REGENERATIVE AGRICULTURE IN RICE-WHEAT- MAIZE SYSTEM FOR INCOME GENERATION

Project Title	Regenerative Agriculture in Rice-Wheat-Maize System for Income Generation
Report Title	VCS Joint Validation & Verification Report of Regenerative Agriculture in Rice-Wheat-Maize System for Income Generation
Version	2.8
Report ID	VCS.VAL.23.16
Verification Period	06-May-2019 to 31-May-2022
Client	Grow Indigo Private Ltd.
Pages	292
Date of Issue	15-January-2026
Prepared By	Earthood Services Limited
Contact	Physical address: 1203-1205, 12th Floor, Emaar Digital Greens, Tower B, Golf Course Ext Rd, Baharampur Naya, Sector 61, Gurugram, Haryana 122011 Telephone: +911244204599 Email: info@earthood.in

Earthood Services Ltd. (Earthood) has carried out the validation and verification of the project, “Regenerative Agriculture in Rice-Wheat-Maize System for Income Generation” (VCS 2590). This project falls in the category, “Agricultural Land Management (ALM)” under sectoral scope 14 - Agriculture, Forestry, and Other Land Use (AFOLU) according to VCS Standard, v4.5. This is a large project activity, implemented by Grow Indigo Private Ltd, the other entity involved are Indian Agricultural Research Instit

Figure 1 Land field overlapped with highway.

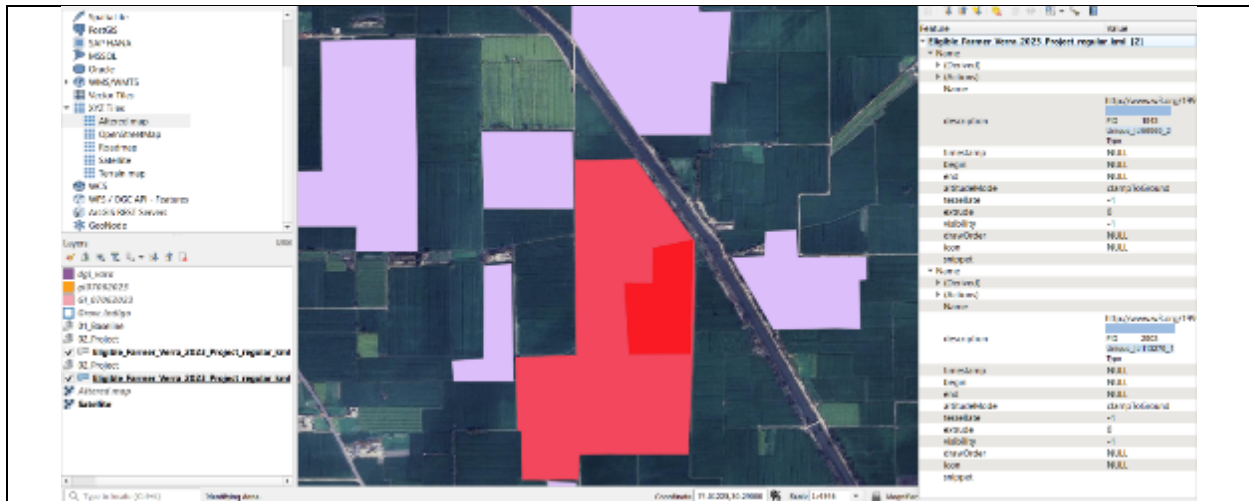
1. The KML file (02_Project.kmz) exhibits various types of overlap cases, including:
 - a. Instances where roads/highways pass through the fields (refer to Figure 1).
 - b. Presence of smaller fields contained within larger fields (refer to Figure 2).
 - c. Overlapping of land fields with other fields (refer to Figure 3).
2. It is recommended to include separate fields for farmer ID and farm ID in the attribute table. While this information is currently present in the description field of the attribute table, the inclusion of separate fields would facilitate a more detailed assessment of the file.
3. It is unclear why certain fields such as Area_Acre, RS19, RS20, and RS21 have been removed in the new file that was shared. Further clarification is needed regarding the rationale behind these field exclusions.

Figure 12: ZT_CT Raster 2021 for UID 1 (COMPOSITE ID: 4571_3)

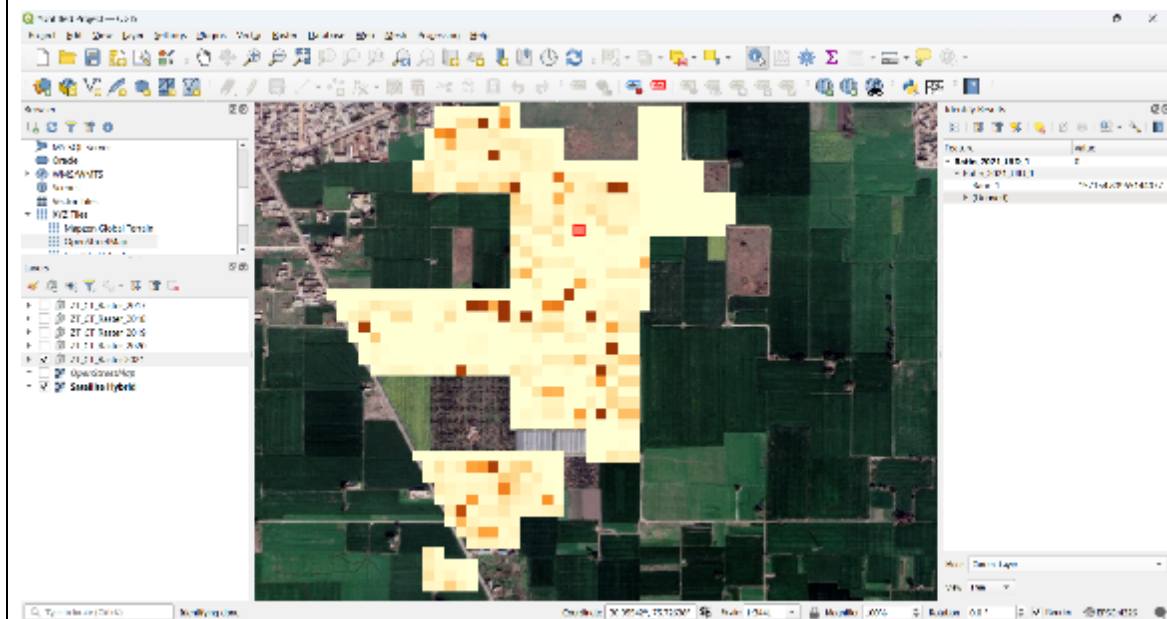
- Classification Threshold and Methodology: It is noted that no threshold was used for DSR and TPR classification, with the majority concept applied for classification. However, there appears to be an inconsistency: In row 7 of the provided figure, the farmer is classified as practicing TPR despite an equal number of 0s and 1s from columns Y to AD, which seems conservative. In a similar scenario, row 6 is classified as DSR, potentially overestimating and not conservative. Please provide the SOP for such cases. Additionally, farmer-reported practices are missing in some instances as discussed however as per the table provided in your response to CL#05 dated 10/06/2024 farmer input is required to determine final activity type in such cases.

- Dataset Provision: PP is requested to provide the NDVI and LSWI datasets over the project activity's temporal scale for the sampled fields to enable cross-validation of the backscattering-based classification criterion. Additionally, provide the NDVI and LSWI time-stamped data (ideally the date & time when the model was developed) files used for ground truth validation during model validation.

- Folder Clarification: Provide clarification on the contents of the LEFT and RIGHT folders within the evidence provided. Further assessment will proceed upon receiving this clarification.

Figure 25: UID_1 (Model Sampled Fields)

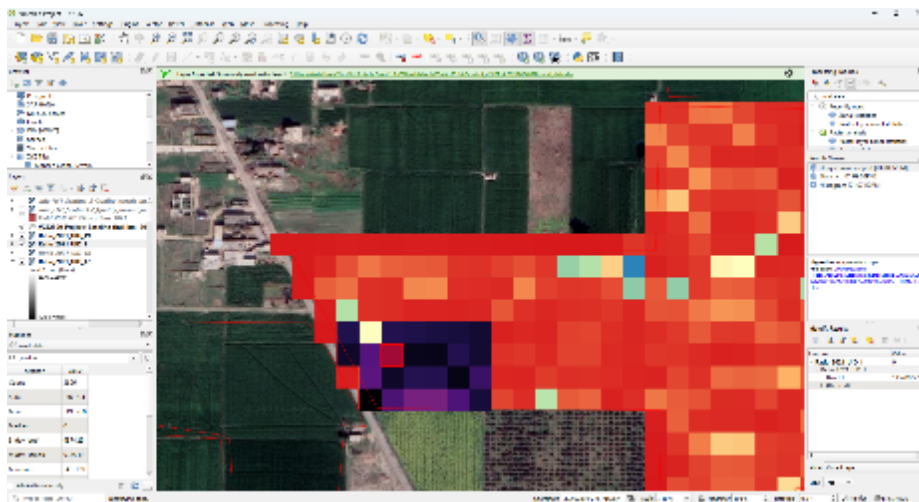
- Revisions and Negative Values: In recent revisions, the PP used absolute values to counter negative values. The PP is again requested to clarify how extreme variations in values over the years are considered for model reliability in verifying project activity for each farmer. The conservative approach is noted as per the description provided in the CL#05 PP response dated 10/06/2024. However, further assessment is needed/ provided post-demonstration of threshold validity as described in previous section i.e. Threshold and Analysis Reporting.

- Median Calculation Method: The median values were calculated over all pixel values (CARI:NDTImax) for the given UID (e.g., UID 1) and the given year (e.g., 2021). The PP is requested to clarify whether a weighted median approach or a simple median approach was used for the analysis. The VVB assessed the raster image provided by PP using a Python script and QGIS, finding the median value of all raster pixels (individual) to be -1929.947263, as previously reported in the CL#05 VVB assessment dated 28/06/2024. The PP is requested to provide a step-by-step analysis for the being conservative and validity of results if weighted median approach is used.

Histogram showing the sowing dates of all fields that had initiated DSR practice in the year 2019. 80% of the fields initiated the DSR practice after June 1st 2019.

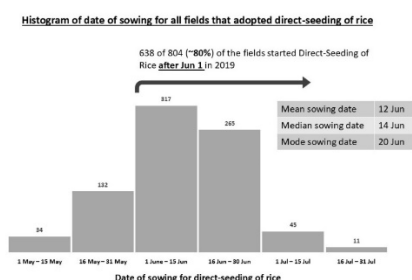
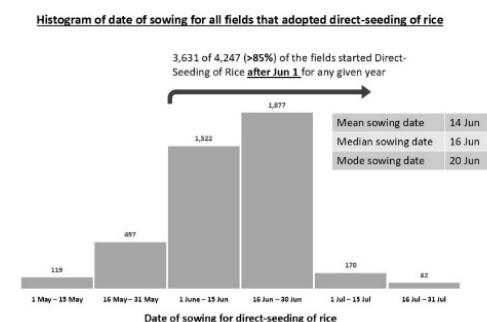
1. PP's response on the ALM project activity that was used to determine the project start date has been reviewed and found to be in line with the VCS Standard. Finding stands closed. 2. The PDMR section 1.8 states that "The project start date was validated through remote sensing analysis, in conjunction with farmer reported data.". It is not clear which activity followed to identify the start date. Further, it is written that "The project officially began on June 1, 2019, to align with the onset of land preparation activities for DSR. Farmer practices were documented through post-hoc attested surveys, as monitoring commenced in September 2021". PP is to clearly explain if remote sensing data is used for start date identification and June 1, 2019 has been identified as start date, then what is the purpose of surveys commenced in September 2021. As per the response provided by the PP, it's unclear how the start date of the project was confirmed based on the ground truthing data collected in 2021 and 2022. Hence, PP shall clarify the same. Additionally, the PD/MR section 1.8 clearly states that, "To differentiate between DSR and TPR, satellite imagery from the May-July sowing window is essential". Therefore, PP shall provide evidence confirming the project activity started on 06/05/2019, in order to verify the same. CAR#31 stands open.

Project participant response	Date : 11-11-2024
2. Establishing a start date for a 'grouped project' involving multiple fields (hundreds of fields) is inherently complex due to the variability in agricultural practices across the fields. Each field within the project operates on its own cultivation cycle, influenced by factors such as crop type, local climate, geographical location, and specific management practices. These variables result in different sowing and harvest dates across individual fields. Since the start date of the project influences the timelines of the GHG emission calculations of all fields enrolled in the carbon program, it is crucial that the start date of project activities applies to majority of the fields enrolled in the program. In our project database, the window for sowing rice under the Direct Seeded Rice (DSR) practice in 2019 ranged from May 6 to July 31 (see figure below). However, about 80% of our farmers (i.e., 638/804) in the year 2019 initiated the DSR practice after June 1st (see graph below). Furthermore, evaluation of the start-dates of all the farmers across the monitoring period (2019-2022) also indicates that 85% of the farmers have initiated DSR practice after June 1st. A statistical evaluation of the start dates of the farmers in 2019 indicates that mean start date of farmers falls on 12th June while for all the farmers across the monitoring period of 2019-2022 falls on 14th June. Therefore, we had used June 1st 2019 as our start date as majority of the enrolled fields have initiated their project activities after June 1st. This will also enable accounting of all the farmers enrolled in the program with a rather simplified approach. Also Net GHG emission calculations of the farmers are based on the modelled data wherein, each field has been modelled based on the exact sowing and harvesting dates reported.

Histogram showing the sowing dates of all fields that had initiated DSR practice in the years 2019-2022. About 85% of the fields initiated the DSR practice after June 1st, 2019 in any given year

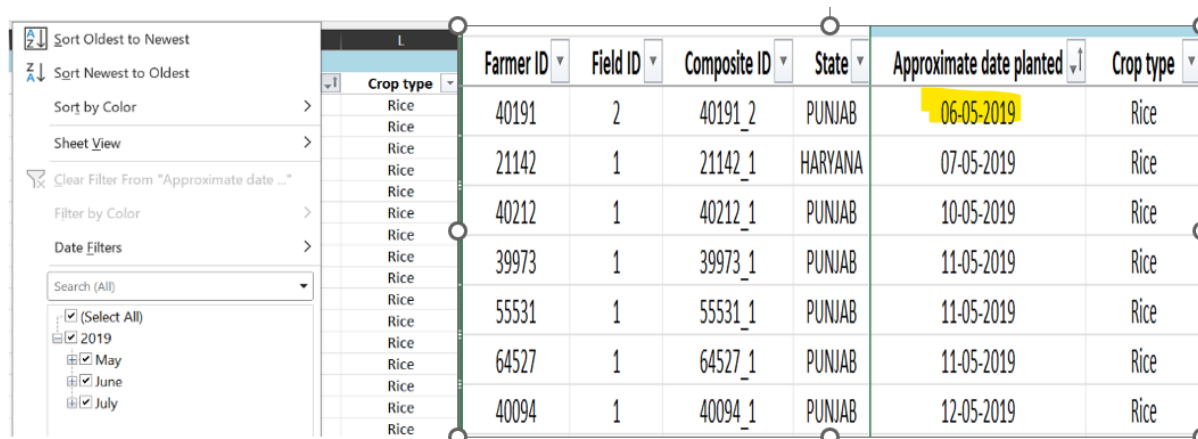
- The response provided by the Project Proponent (PP) was reviewed and found that 34 farmers had initiated Direct Seeded Rice (DSR) practices between 01th May and 15th May, 2019. PP's statement of 1st June, 2019 as project start date is inconsistent with VCS Standard section 3.8 (project start date of an AFOLU project is the date on which activities that lead to the generation of reductions or removals are implemented). PP is requested to submit primary evidence (other than remote sensing analysis) referred for implementation of exact project activity on mentioned dates. Also, evidence of how the above histogram was derived.

Therefore, CAR#31 stands open.
